TECHNICAL BULLETIN
K250 UPS5914-5bNAS1
25 SEP 2014

Update Prior to Sale: Undertray Rework To Remove Steering Gear Gaiter Foul

XJ Range (X351)
Model Year: 2015
VIN: V75431-V76851

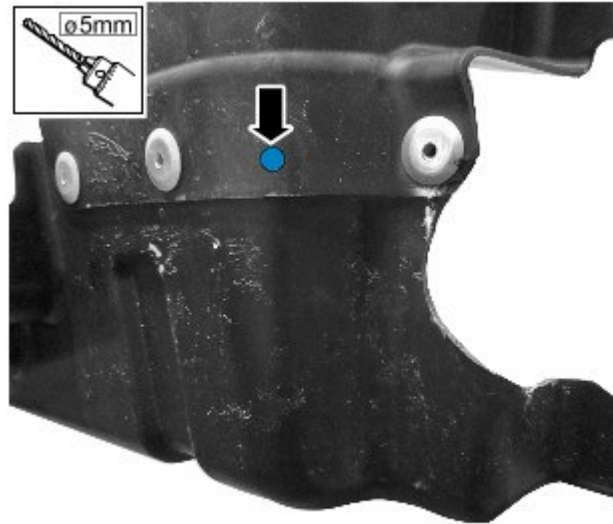
1. Remove air deflector (see TOPIx Workshop Manual, Section 501-02).
2. From SSM71981, print off the left-hand and right-hand templates.
3. Install the right-hand template to the right-hand-side of undertray assembly.
 - Mark the new rivet location and excess to be removed from the undertray assembly.

E171090

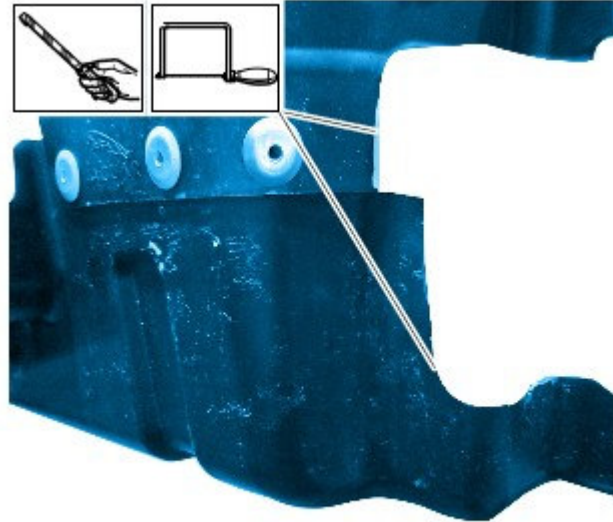
8. Using a suitable tool, cut away the marked up area in the undertray assembly.

E171096

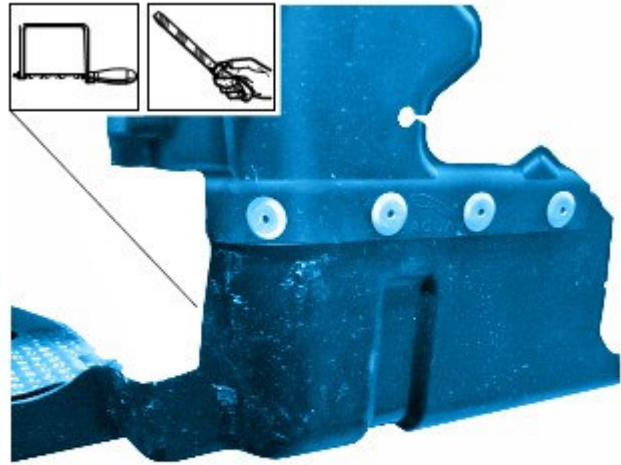
15. Using a suitable tool, cut away the marked up area in the undertray assembly.

E171101

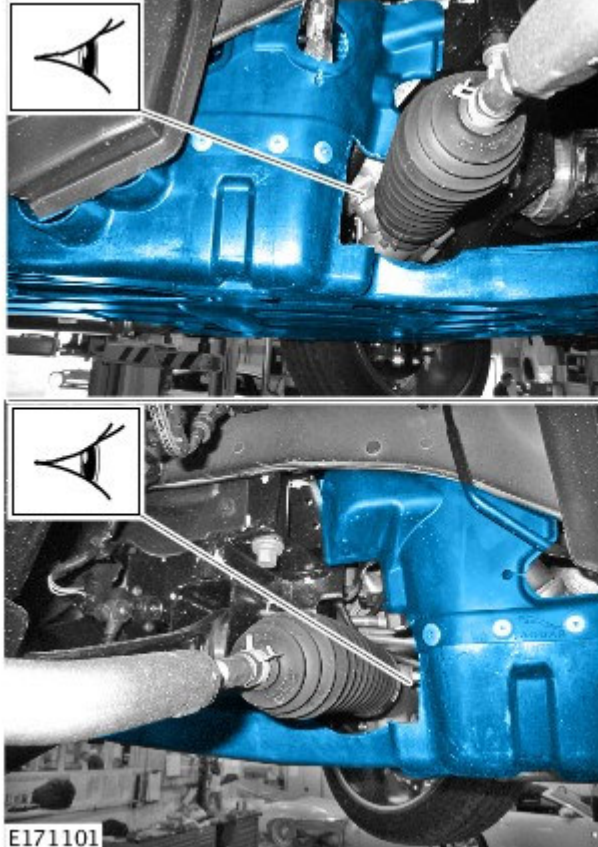
18.  **NOTE: Both left-hand-side and right-hand-side must be checked.**

Check that there is a minimum 18mm clearance between the steering gear gaiter and undershield.
